**Responses to Agencies' Comments (September 8, 2017)**  
**"Revised Draft Feasibility Study Technical Memorandum #1: Development and Screening of Remedial Alternatives, Smoky Canyon Mine RI/FS" (March 2017)**  
**November 16, 2017**

**General Comments**

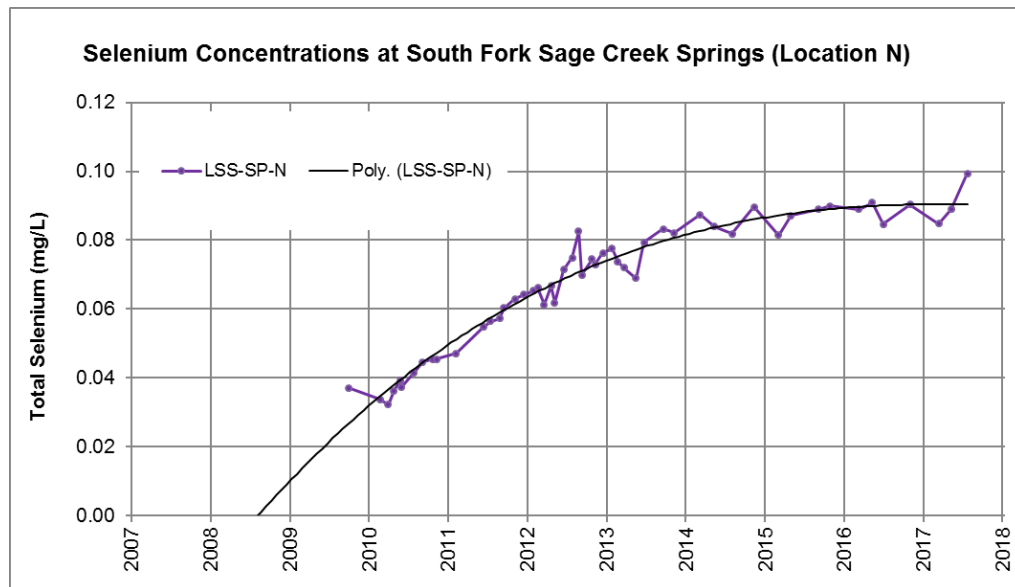
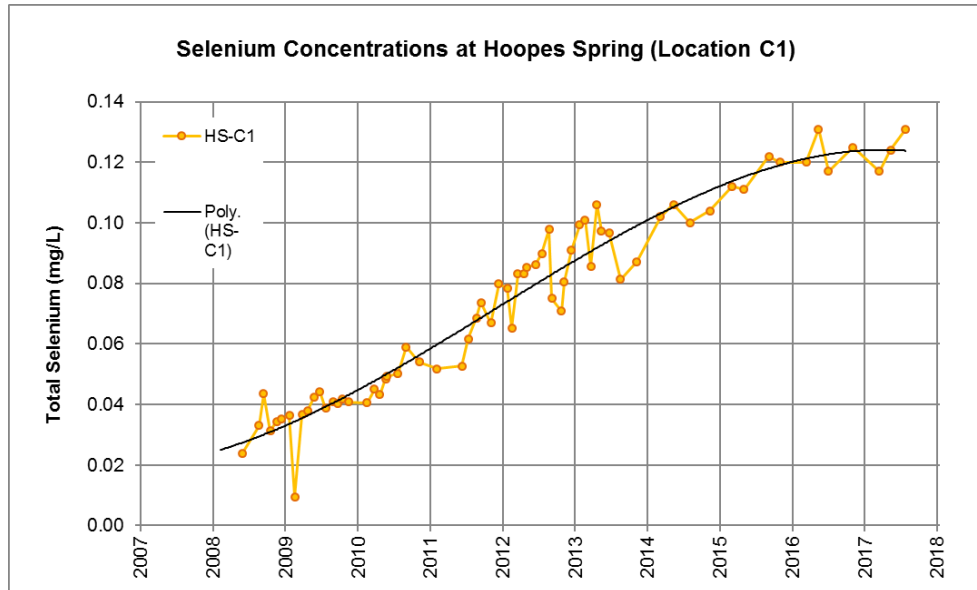
**SC-12 Section 2.4.2, Page 2-19, Migration Routes, Groundwater, paragraph 4.** The text indicates that the modeling estimates that the selenium load at the spring's complex will peak in 2015/2016. It is currently 2017. How do measured concentrations compare to the predicted concentrations?

**Response:** The selenium concentrations are shown on the figures below, along with a polynomial regression line. As shown, it appears that concentrations are in their peak range at both Hoopes Spring and South Fork Sage Creek Springs. Concentrations are in the range predicted by the RI model:

- HS-3 predicted peak concentration 0.09 mg/L (the average of the last 4 measurements is 0.098 mg/L);
- LSS predicted peak concentration 0.02 mg/L (the average of the last 4 measurements is 0.019 mg/L).
